PRELIMINARY OVERALL AREA DEVELOPMENT PLAN
P.O.A.D.P.

SANTIKOS 281/1604

Re: Santikos 281/1604

POADP # 327-D

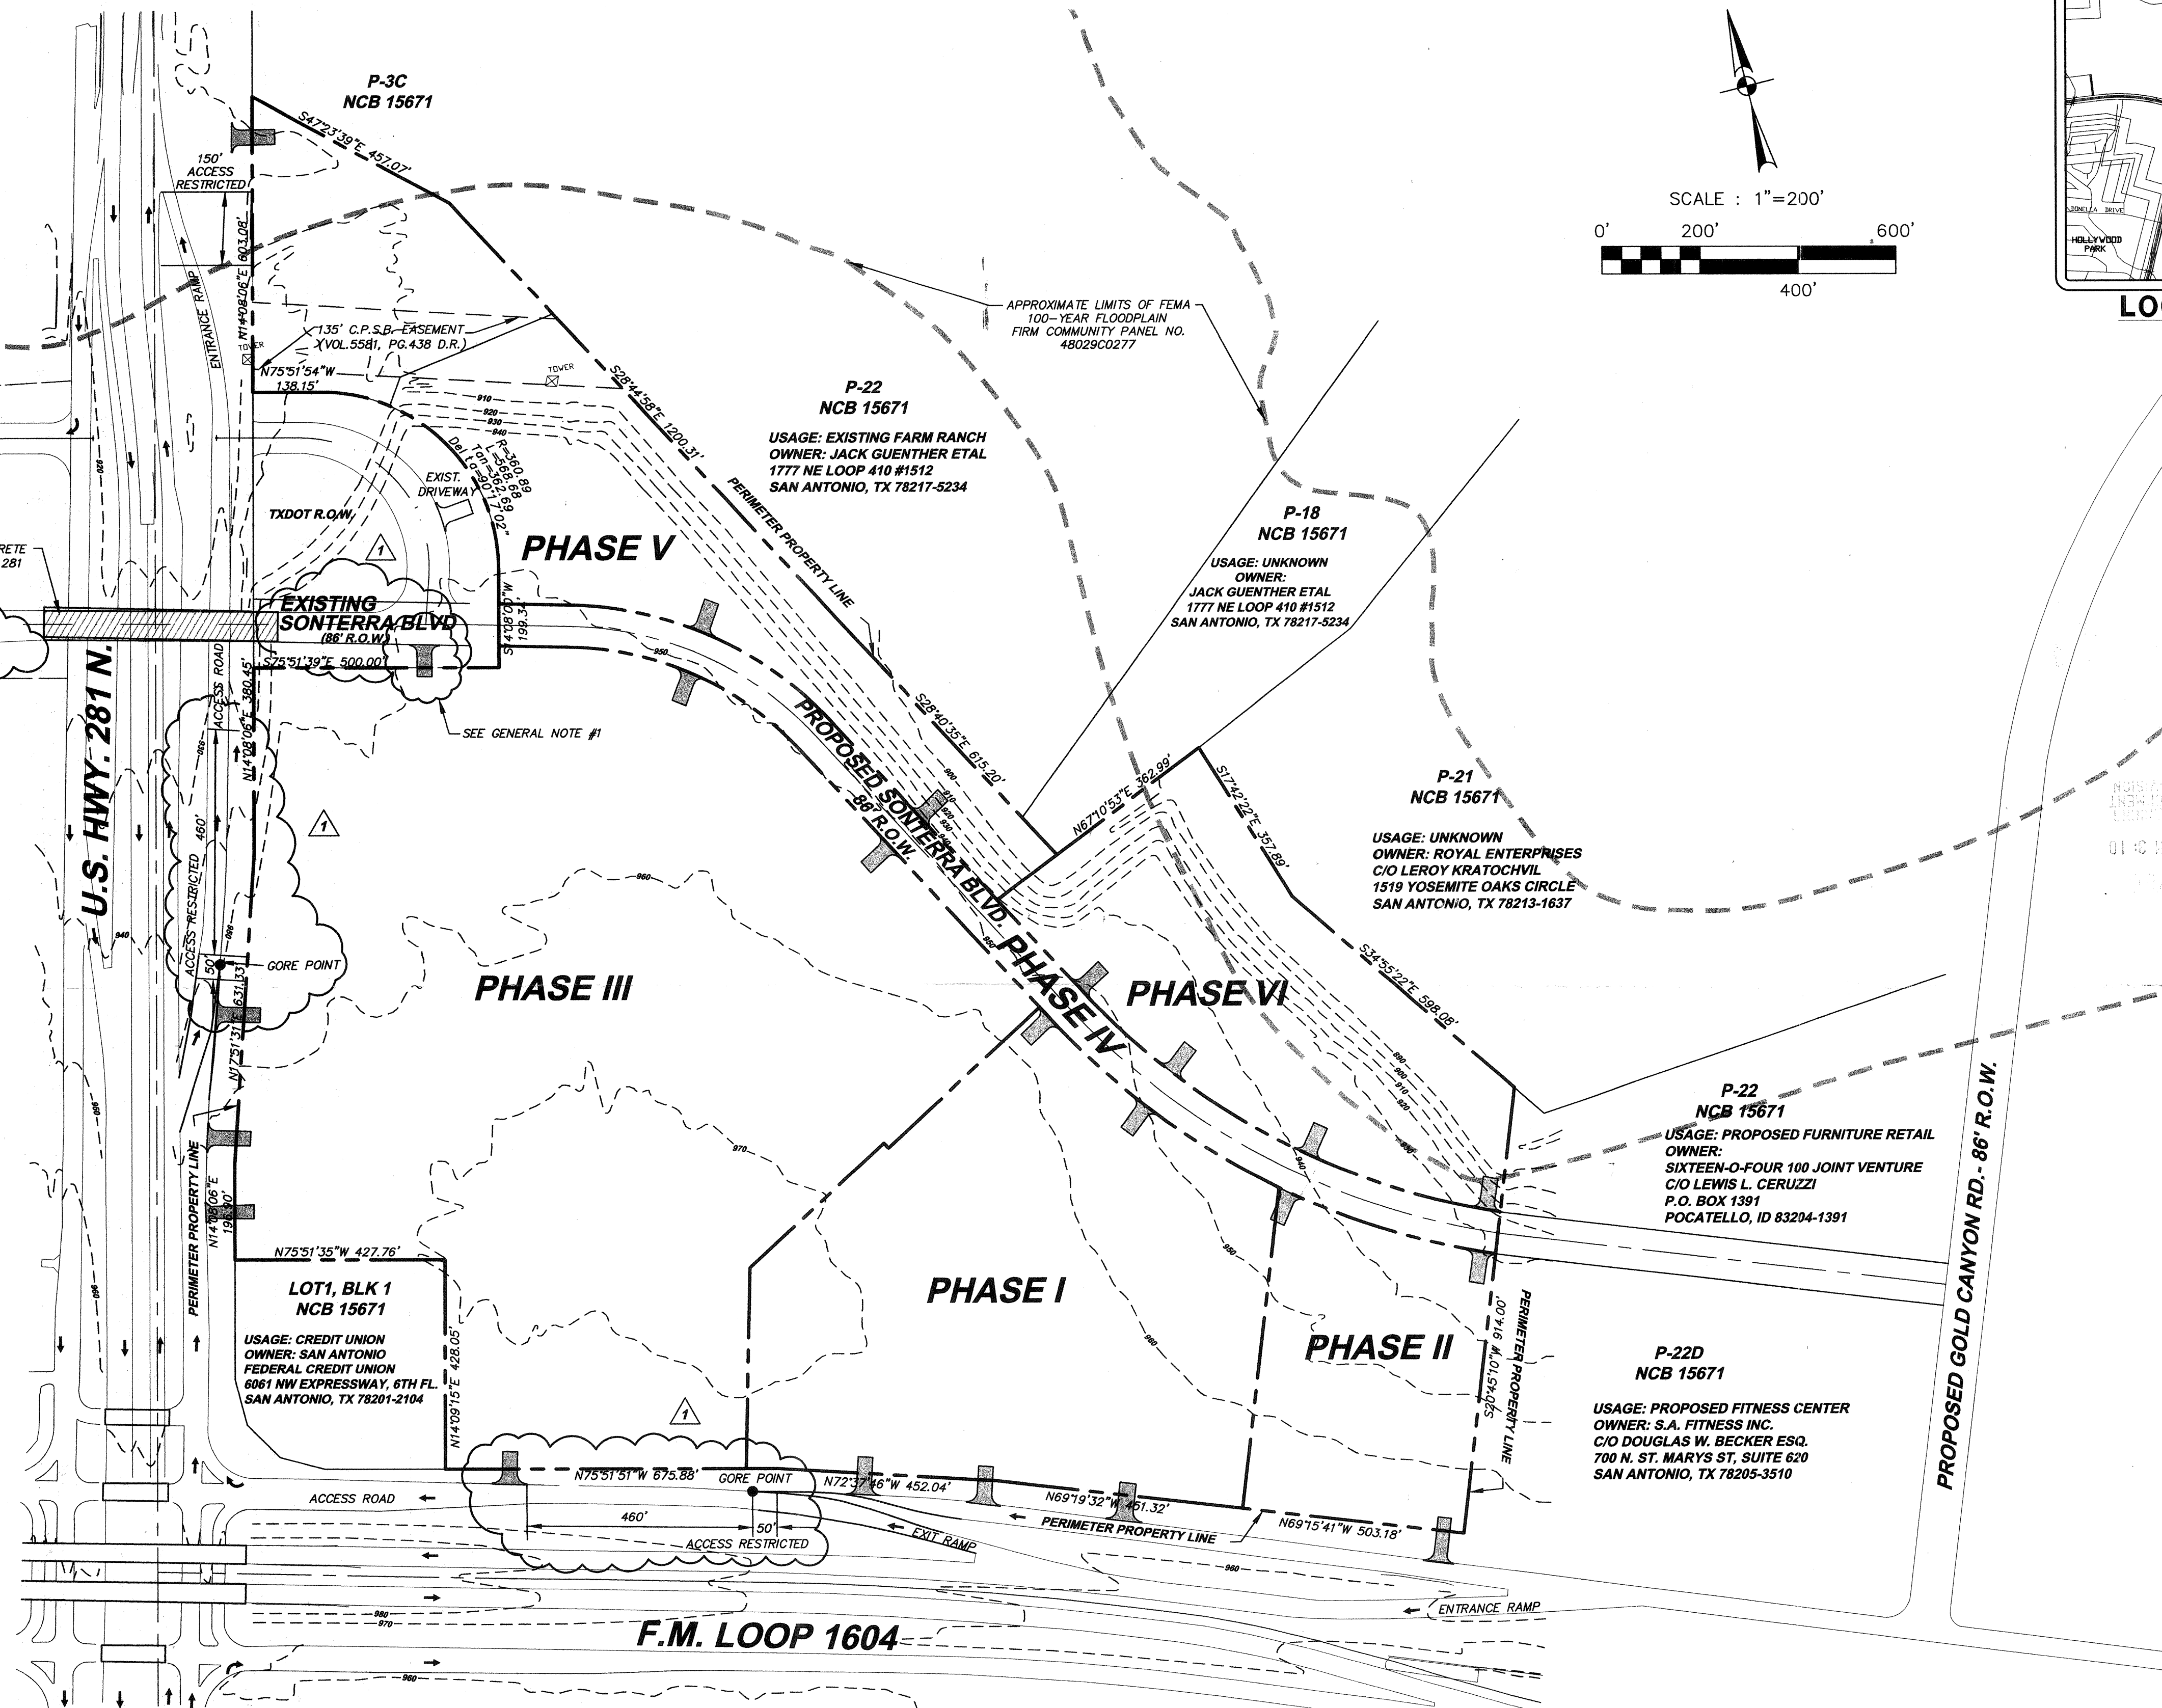
(a) Perimeter property lines. **Are not clear and distinct.**

(e) Existing and proposed circulation system of collector, arterial, and local type B street and their relationship to any adjacent major thoroughfares; and any proposed alternative pedestrian circulation system. **Were not provided.**

(h) Existing adjacent or perimeter streets (including right-of-way widths), intersections, and developments. **Were not provided.**

The proposed driveway that general note #1 refers to must be supported by an official letter from Tx-Dot or eliminate it from this submittal.

(d) Paragh, (2) The resulting additional ingress and egress of vehicles **Will** seriously disrupt the flow of traffic on the thoroughfare. A 1'-non accesses esm't will be required on the properties adjacent to the proposed collector.

3.) Access needs to be provided to the adjoining properties for connectivity.

The perimeter property lines were clear and distinct on the POADP which was submitted for review and approval. All perimeter property lines were labeled with bearings and distances. We have added the label "Perimeter Property Line" to the drawing.

The existing and proposed circulation system of collector, arterial and local type B streets and their relationships to any adjacent major thoroughfares were clearly documented on the POADP. The existing Sonterra Blvd. crossing of US 281 was documented along with the current lanes of US 281 and Loop 1604. The proposed layout of Sonterra Blvd. east of US 281 and the proposed Gold Canyon extension north of Loop 1604 were clearly shown and labeled. Currently there are no plans for the construction of other public arterials or local type B sheets within the limits of the property.

Existing adjacent or perimeter sheets, intersections and developments were clearly provided and labeled on the POADP. The proposed adjacent land uses were clearly labeled to the best of our knowledge.

The proposed driveway that general note #1 refers to was supported by an official letter from TxDOT dated April 18, 2000 addressed to Ms. Elizabeth Carol and was addressed as follows under their additional comments:

"It was discussed at the February 16, 2000 meeting between TxDOT, Santikos, Pape-Dawson Engineers, Inc. & WHM Transportation that TxDOT may permit an access point along this call in the future, once the fully directional interchange is constructed at Loop 1604 and US 281, and US 281 is expanded accordingly."

The POADP process can not restrict public access under the Unified Development Code. Section 35-4110 "Access from Major Thoroughfares" will be addressed during the platting process. Section 35-4110 (b) addresses the number of access points allowed for lots in commercial, industrial and medium or high density residential developments. The owner shall not agree to a one-foot no-access easement under the POADP process.

Access will be provided to adjoining properties as a result of the proposed construction of Sonterra Blvd.
